Chrysler 4.7L V8 Engines
Engine Identification Bulletin

Cam gear and crank reluctor rings

Cam gears

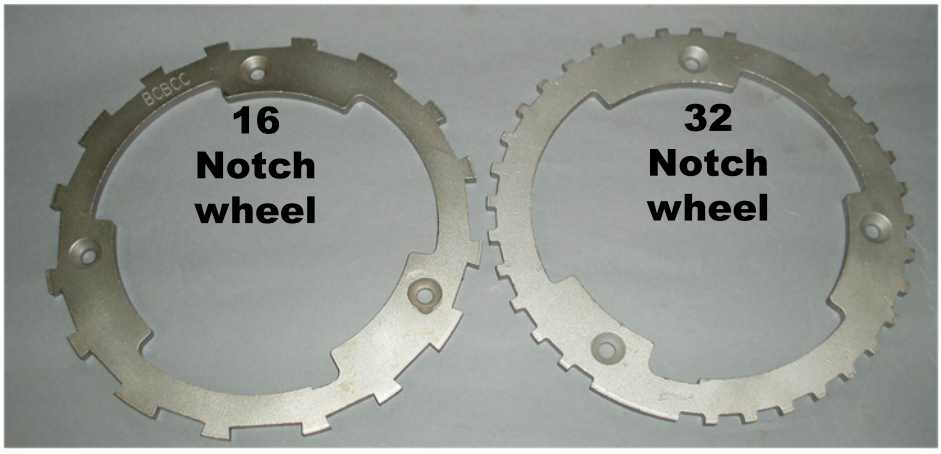
On certain years and applications there are changes in the cam and crank reluctor wheels on these units.

The change is due to the NGC (next generation computers used after 2002. To properly identify these units the timing components must be inspected.

Without N.G.C.
2 Windows near "R"

With N.G.C.
3 Windows near "R"

Crankshaft Reluctor

Without N.G.C.

With N.G.C.
